MEMORANDUM

July 2nd, 2014

SUBJECT: Public hearing and consideration of an application for a Landmark Alteration Certificate to remodel and change the roof form to one side of the contributing accessory building at 2515 7th St. in the Mapleton Hill Historic District, per section 9-11-18 of the Boulder Revised Code 1981 (HIS2014-00190).

Figure 9. Site Plan. Shaded portion indicates footprint of approved addition.

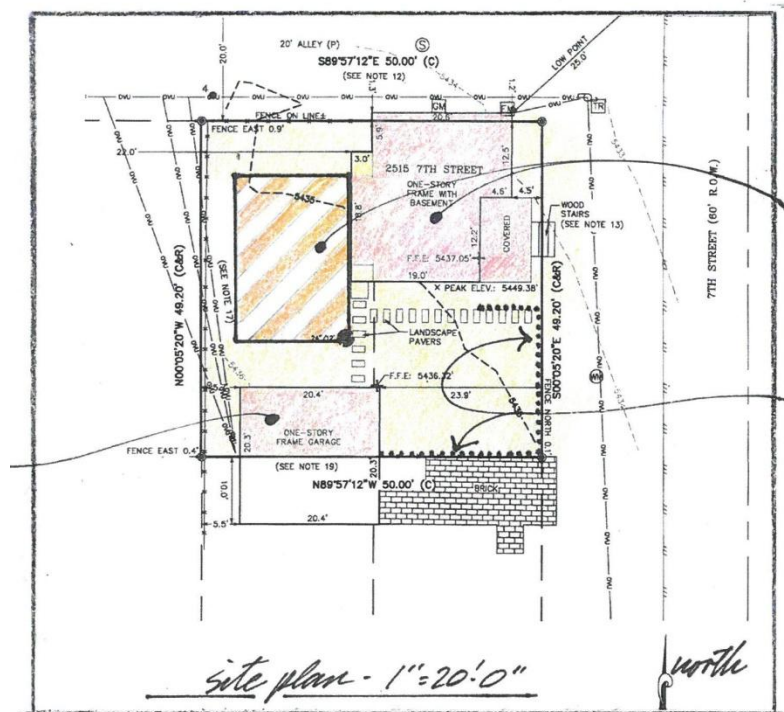
A site plan shows the footprint of an addition to the main house at 2515 7th St. that was approved by the Landmarks Design Review Committee on May 7, 2014. The proposed alterations will not change the existing footprint of the accessory building. A fence is shown along the south property line (bisecting the accessory building), continuing around the portion of the east property line and returning west approximately 10 ft. along proposed pavers.

The application also calls for the construction of a fence extending from the midpoint of the garage along the south and east property lines, and returning

north approximately 10' (see Figure 9). The fence is shown to be 6' in height, with an alternating pattern of 4" and 2" horizontal boards separated by 1" spacing.

Figure 11. Proposed East Elevation (façade)

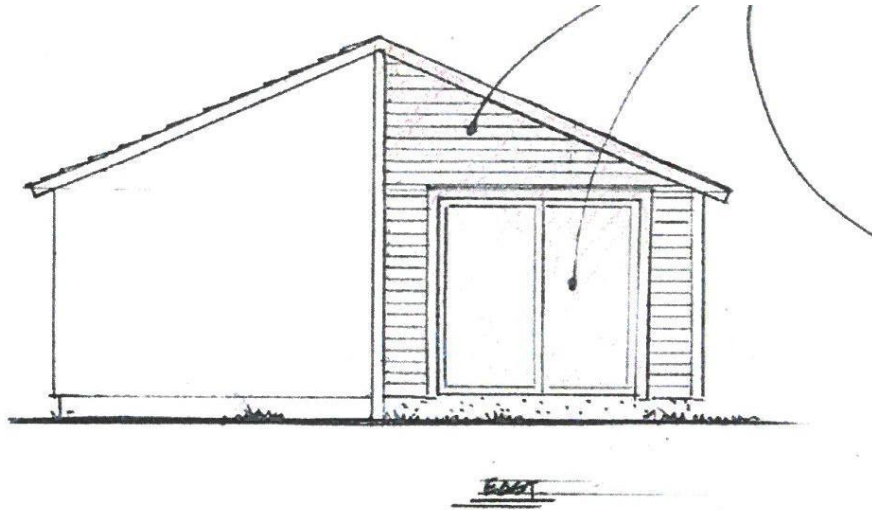
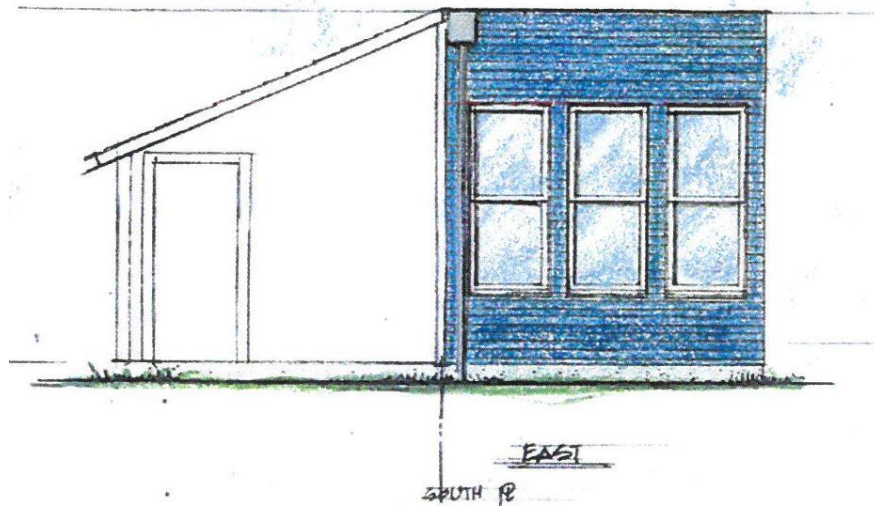
The east elevation of the accessory building sits approximately 24' west of the sidewalk along 7th St. Drawings show the north side of the gable to be raised to create a flat roofed cubic mass measuring 11'6" in height and changing the essential form of the simple gabled garage. The existing sliding glass door is shown to be replaced by three large double-hung windows. The original siding is proposed to be removed and replaced with a narrower lap siding to match the profile and color of the approved addition to the house.

Figure 13. Proposed North Elevation

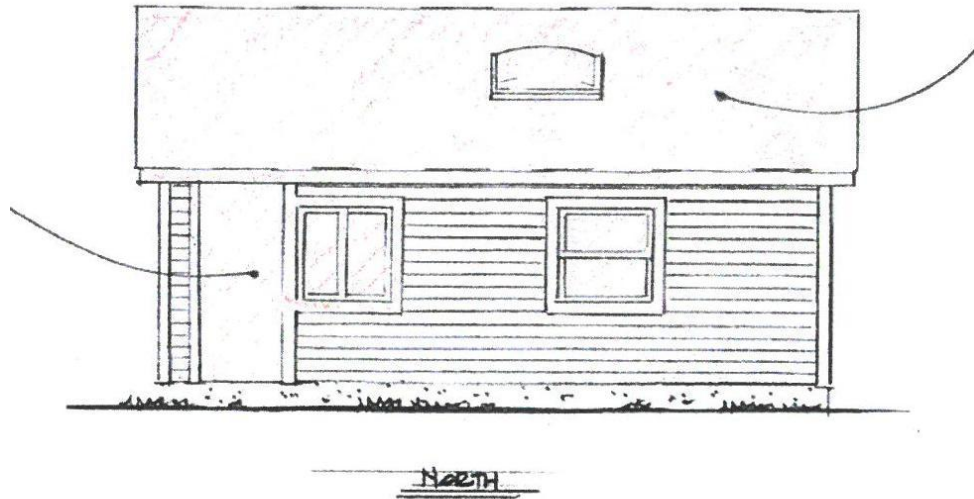
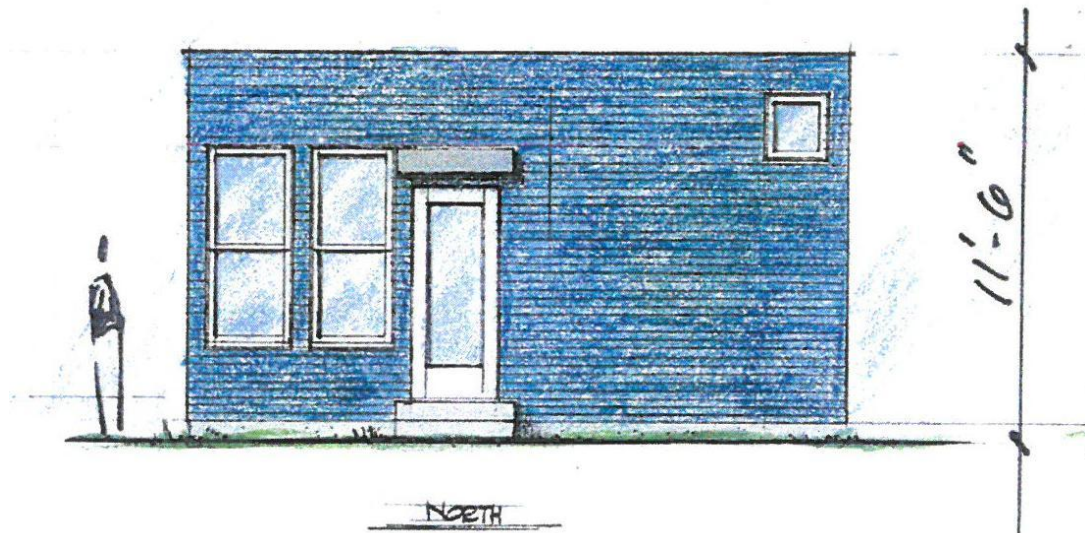
The openings on the north elevation are shown to be reconfigured so the door is near the center of the elevation, with two double-hung windows at the east end of the elevation. A small casement window is shown in the upper corner of the west side. A concrete stoop is located at the full-light pedestrian door. An overhang is shown over the door on the north elevation but is not depicted on the east or west elevation.

Figure 14. Existing West Elevation

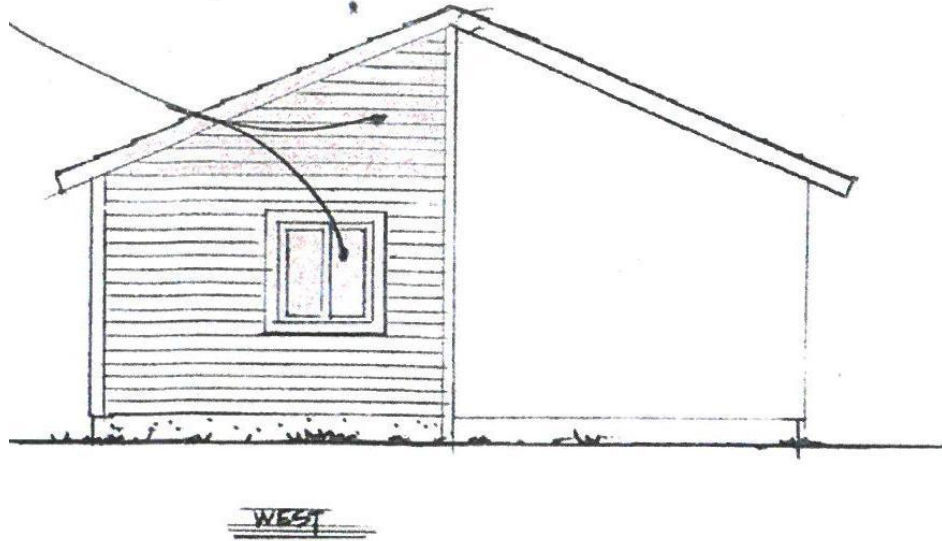
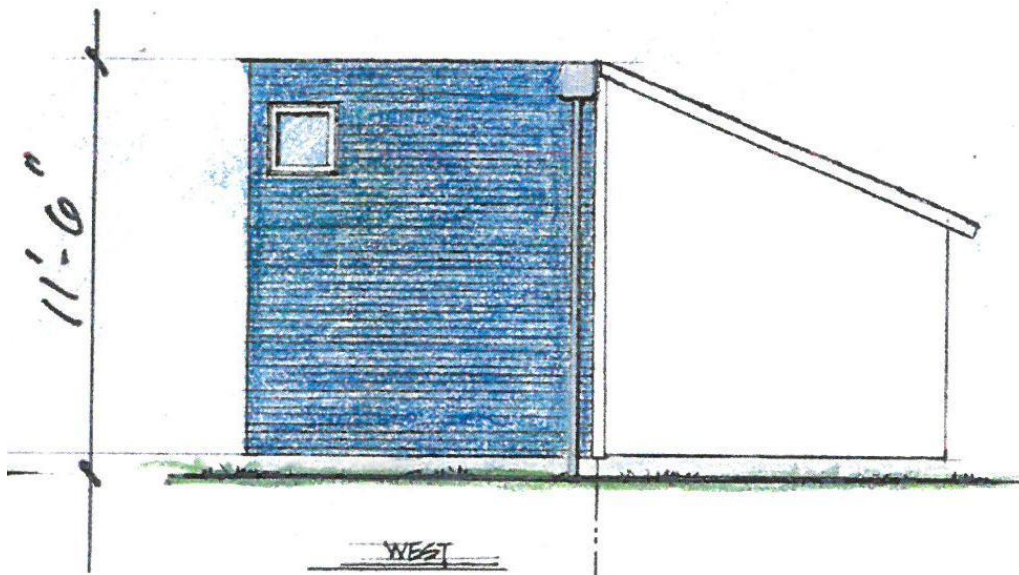
The window opening on the west elevation is to be enclosed and a small casement window located at the north corner of the west elevation. A simple gutter is shown near the center of the west elevation.

Figure 16. Proposed Fence detail

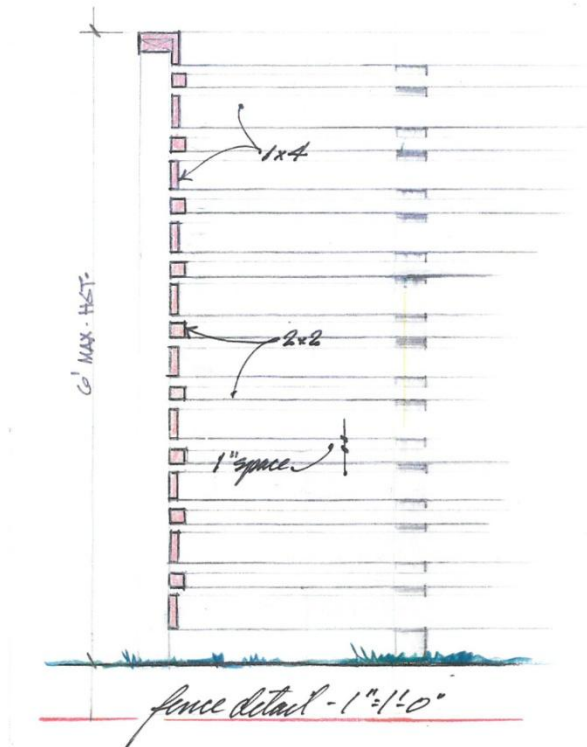
.8	<i>Side yard fences were typically located behind the main house, not in the front yard. Where side yard fences do extend into the front yard, they should be low and open with a gradual transition in height toward the rear yard. The portion of the side fence that extends beyond the front elevation of the building should not exceed a maximum of 36 inches in height.</i>	Proposed front yard fence to measure 6' in height and would obscure the view of the contributing property.	No

<i>wire fencing which are historic and would be encouraged. Low shrub hedges are also appropriate. Vertical board, stockade, chain link fences and heavy brick posts are generally inappropriate.</i>	may be appropriate as the design would maintain visibility of the contributing property.	
.3	<p><i>Fences without spaces between slats can alter the character of a building site and of the streetscape and alley scape because the historic architectural elements that contribute to the pattern of spacing, setbacks, scale, details and materials of the historic district are blocked from view.</i></p> <p><i>a. Solid or tight fences are not appropriate</i></p> <p><i>b. Every effort should be made to allow visual penetration in the design of fences visible from the street or alley. The visual impact of solid wood fencing at the rear of a lot is that the alley becomes a visual tunnel, and much of the irregularity and variation that make the essential character of an alley are changed.</i></p>	Proposed fence to have a minimum of 1" spacing between slats. Proposed 6' height of a front yard fence is not appropriate.	No
